REQUEST FOR DRAWING CHANGE APPROVAL

REMARKS

This is in response to the Official Action currently outstanding with regard to the present application, which Official Action the Examiner has designated as being FINAL.

Fig.7

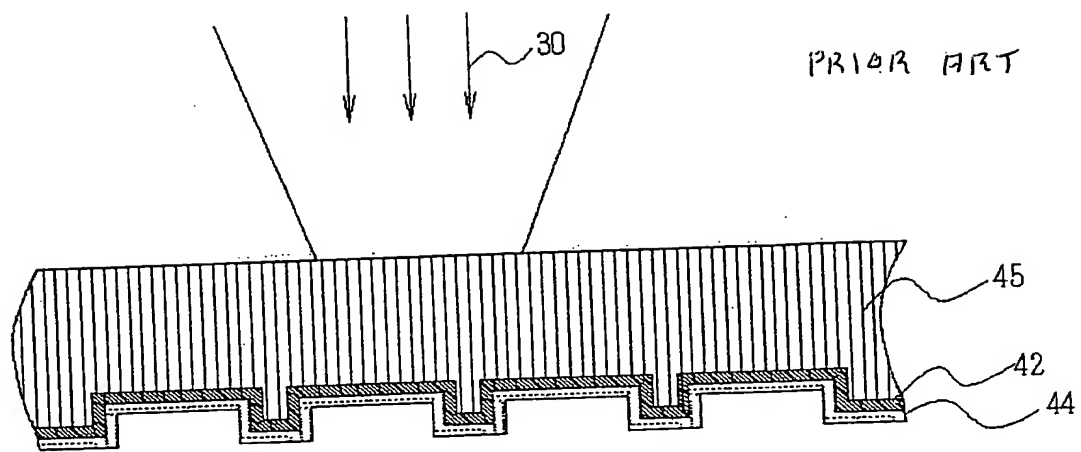
In response to the Examiner's objection to Figs. 7 and 8 of the drawings as filed with the above-identified application on the basis that those Figures should be designated by a legend such as "PRIOR ART" because only that which is old is illustrated therein, Applicant respectfully requests approval of amendments to Figs. 7 and 8 of this application so as to designate those figures as -- PRIOR ART --. The proposed amendments to Figs. 7 and 8 are shown in red on the enclosed photocopy of the drawing sheets of this application containing Figs. 7 and 8. Further, pursuant to the Rules, Applicant is submitting herewith a clean copy of the sheet of drawing of this application that contain Figs. 7 and 8 labeled as "Replacement Sheet" in the upper right-hand margin, and respectfully requests that that clean copy of the sheet of drawing of this application containing Figs. 7 and 8 be substituted for the corresponding sheet of drawing presently on file in this application.

Applicant respectfully submits that this submission of a corrected replacement drawing sheet for the above-identified application removes one of the bases for the Examiner's currently outstanding objection to the drawings of this application. Accordingly, a decision so holding in response to this communication is respectfully requested.
